## PROPOSED LIDL FOODSTORE

Former Hayes Pool and Fitness Centre, Central Avenue, Hayes Town

Response to Highway Officer Comments

On behalf of Lidl UK

**Drawing 15/0302/SK06**

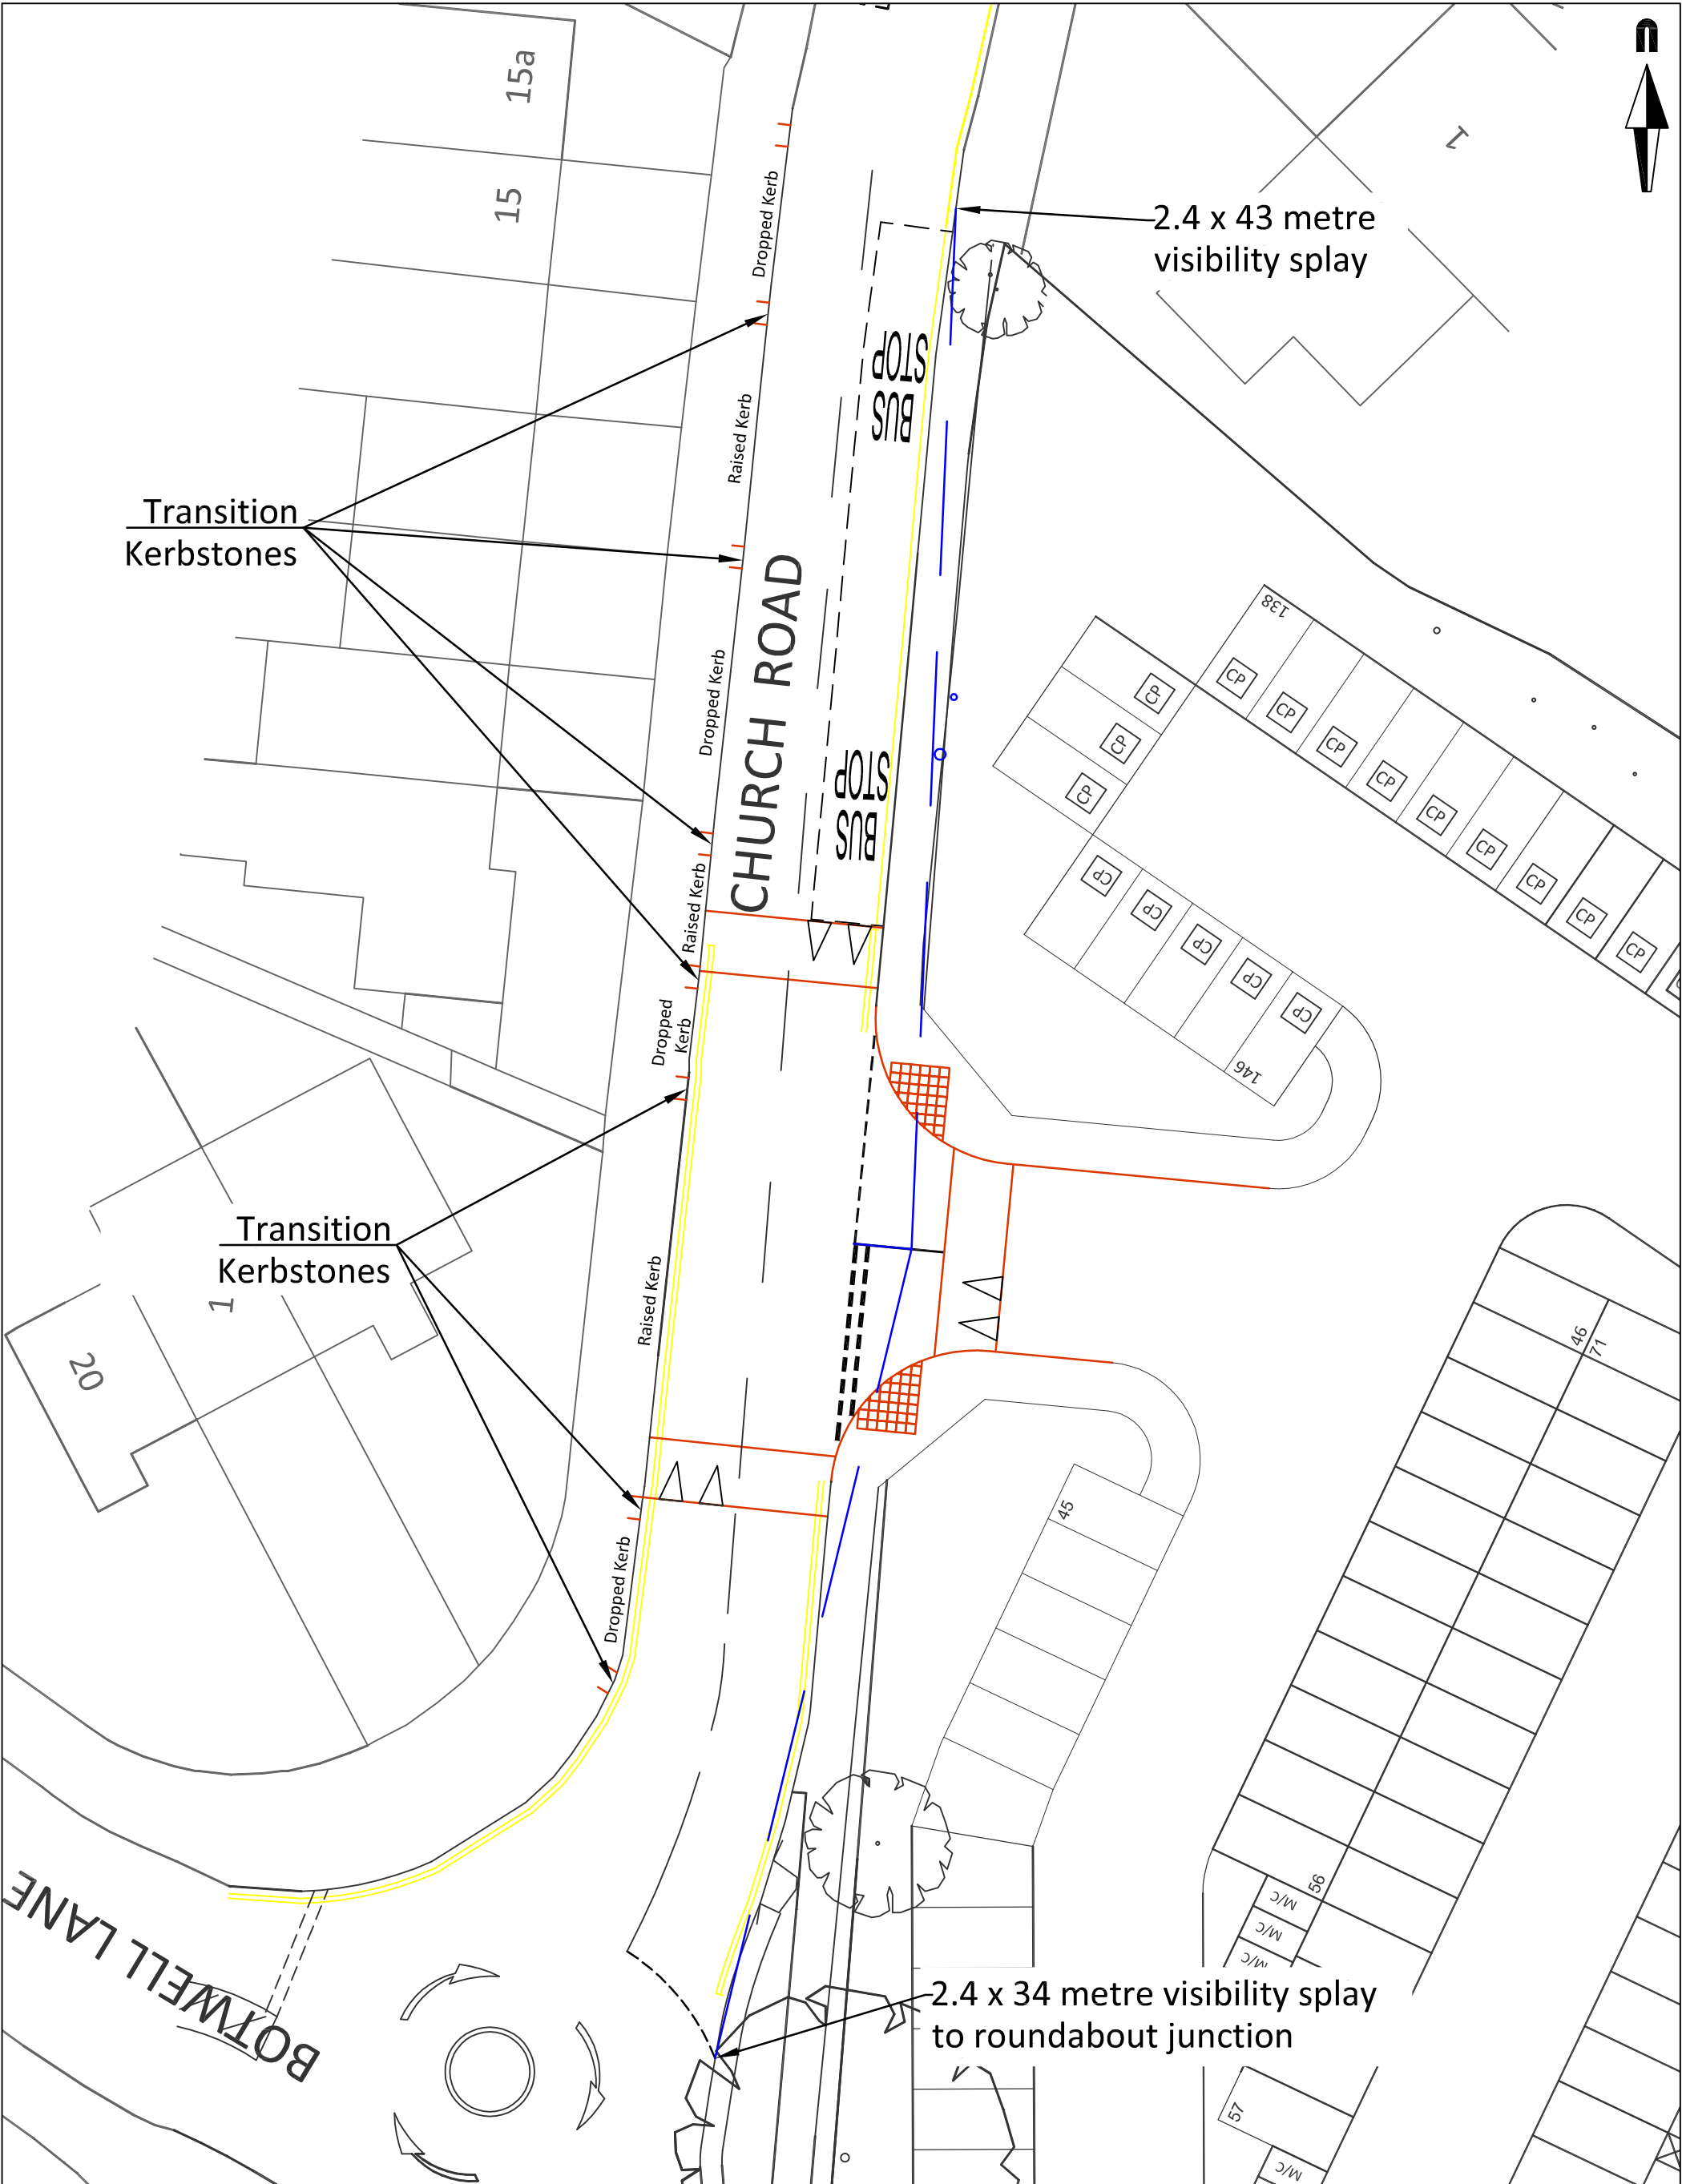
*“Location of the proposed access in close proximity to the bus stop and vehicle crossover opposite is unsatisfactory due to concern relating to sightlines and conflicting traffic movements.”*

- 4 To address the issues with visibility, two drawings have been created to provide the visibility splays associated with the proposed access arrangement. Drawing 15/0302/SK06, which is included at **Appendix A**, demonstrates the achievable visibility splays along Church Road, showing 2.4 by 43 metres to the north and 2.4 by 34 metres to the south, accounting for the proximity of the roundabout junction.

- 6 The practical visibility indicates that 23 metres would be achievable from the Lidl site access junction to the north. This is equivalent to an oncoming vehicle speed of 19 miles per hour. Given the proximity to the Botwell Lane roundabout, it is not considered likely that cars would overtake the bus at the posted speed limit due to potential oncoming vehicles entering the road from the roundabout. On this basis, the practical visibility achievable reflects the likely vehicle speeds in the event that a vehicle is able to overtake a stationary bus.

**APPENDIX C**  
**Site Access Junction - Extent of**  
**Adoptable Highway**

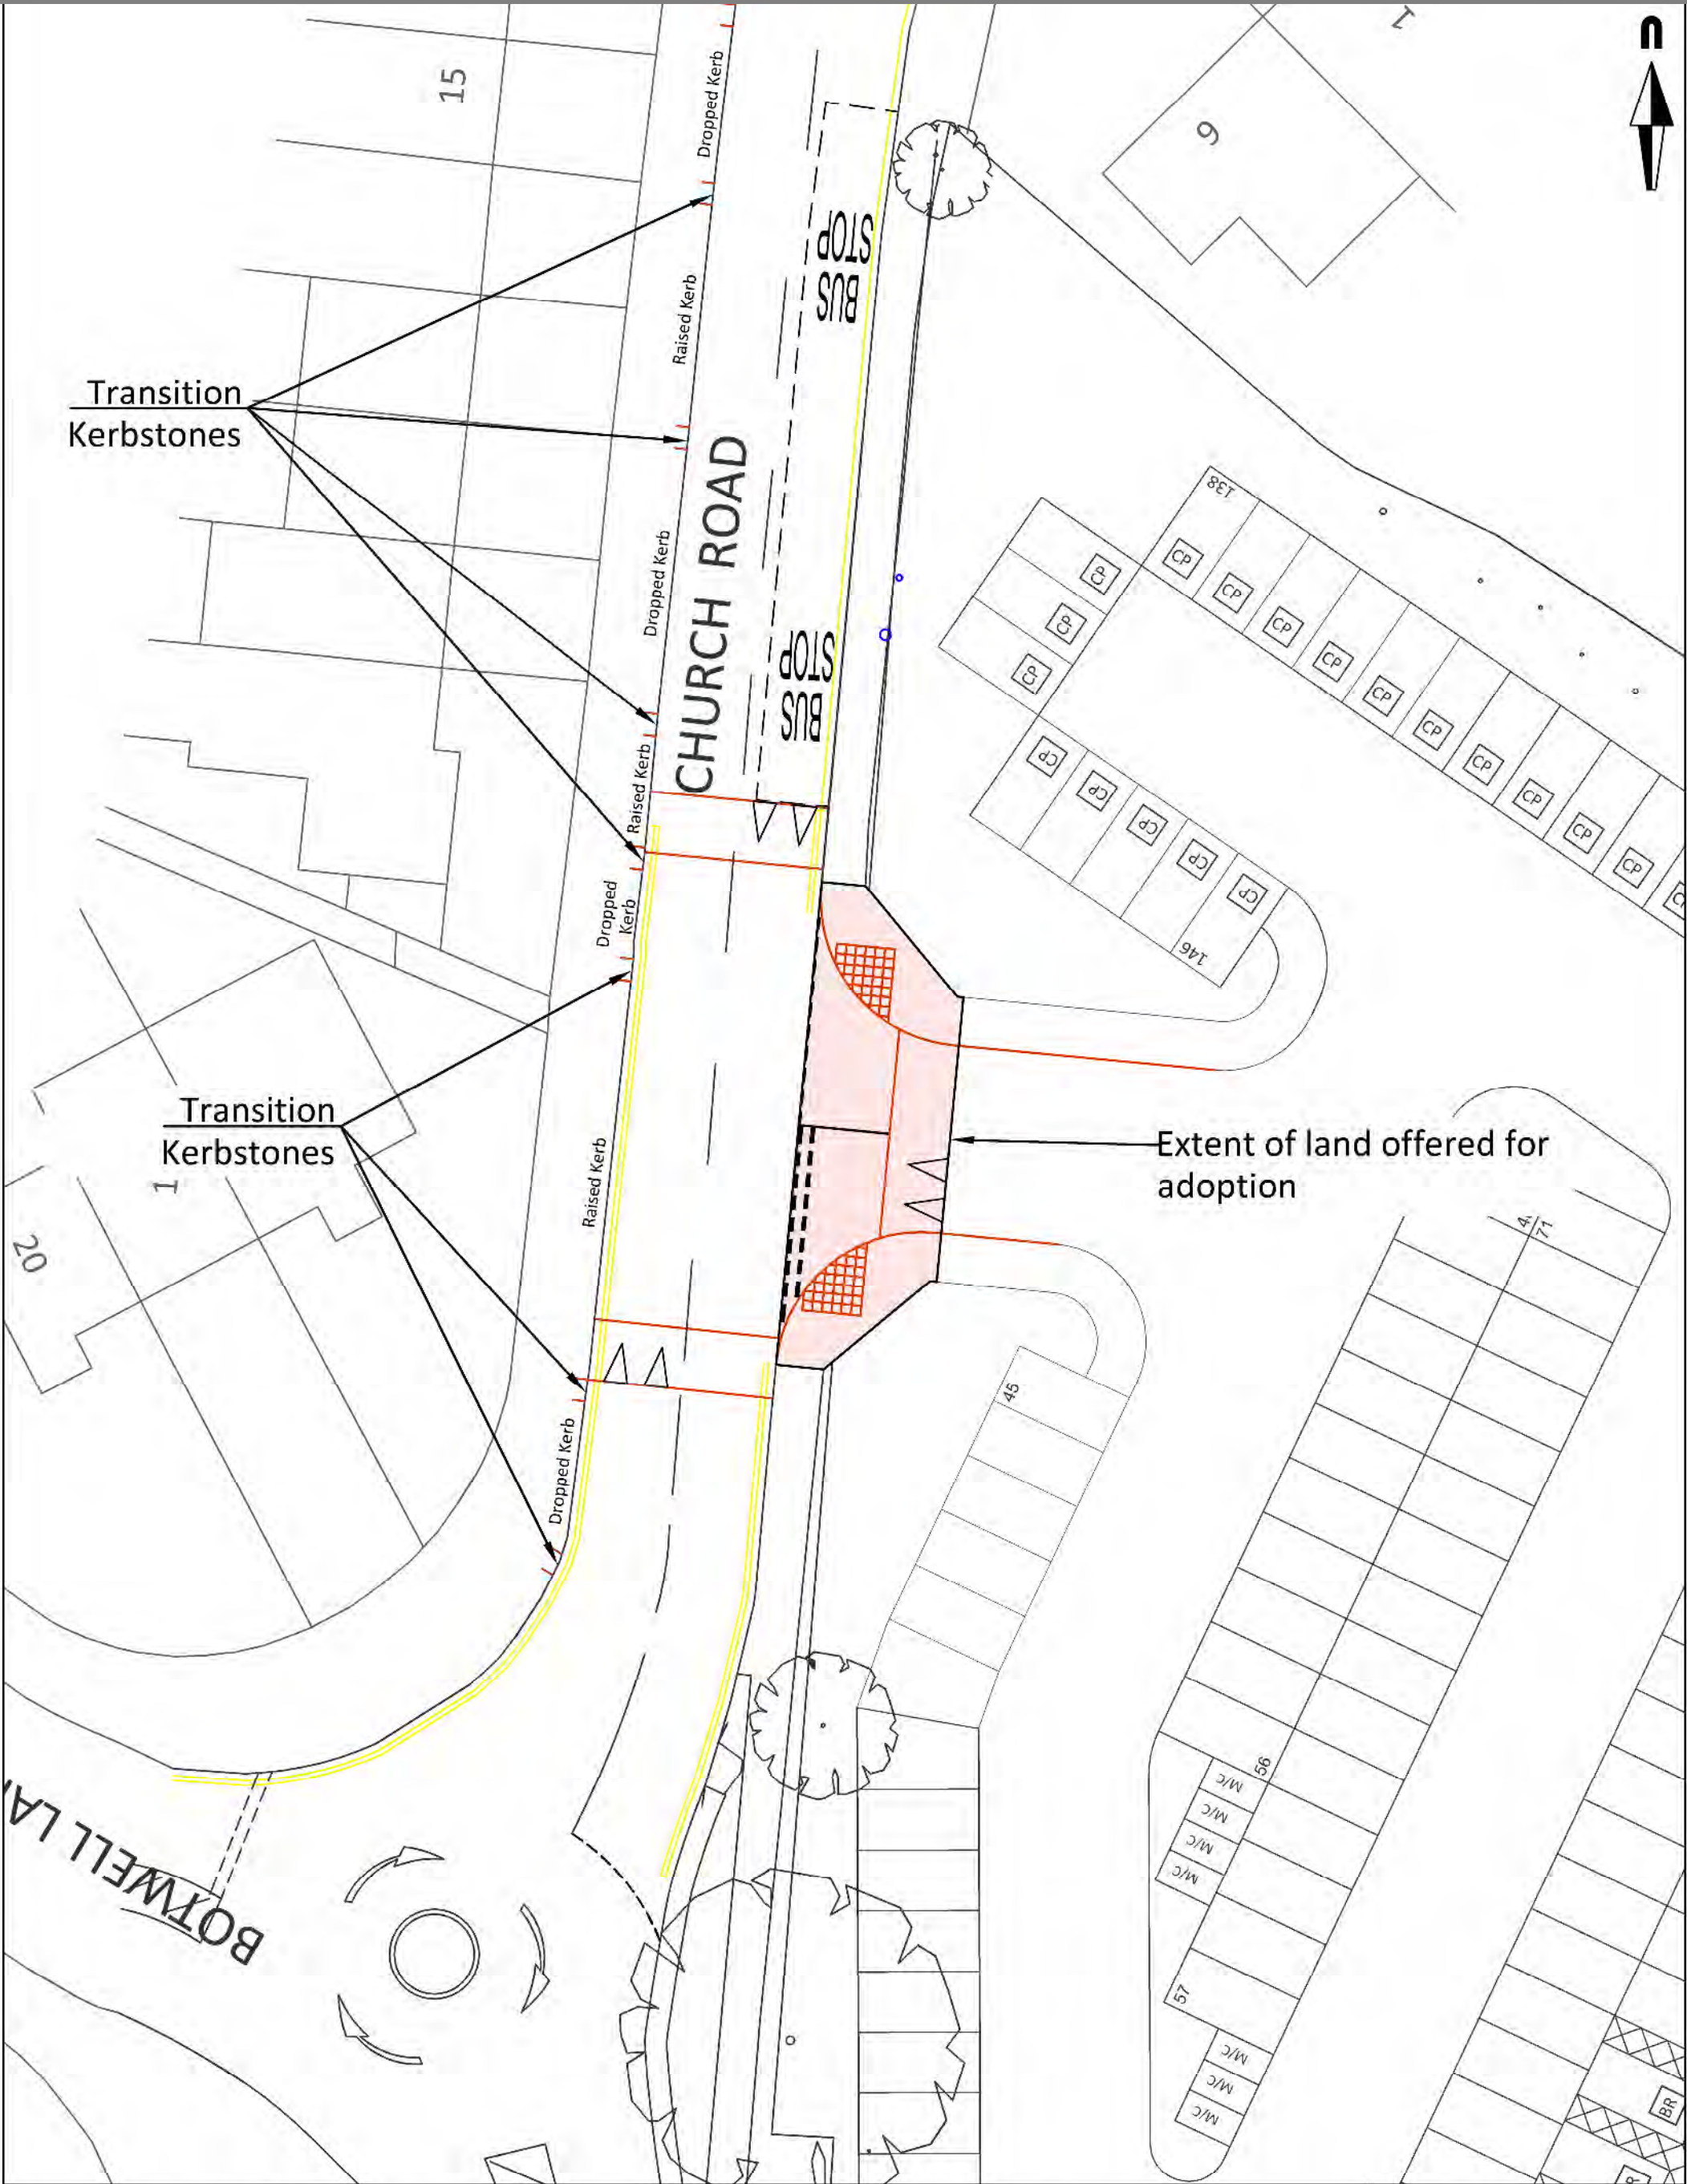
*“The extent of land offered for adoption at the proposed access should be clarified; ensuring safe pedestrian crossing facility and surface drainage from private and public land are adequately addressed. “*

- 12** It is considered that the extent of land offered for adoption would cover the entire raised table and ramp within the Lidl site. This is illustrated in an adoption extent drawing, included at **Appendix C**, which highlights the adoption boundary in red.
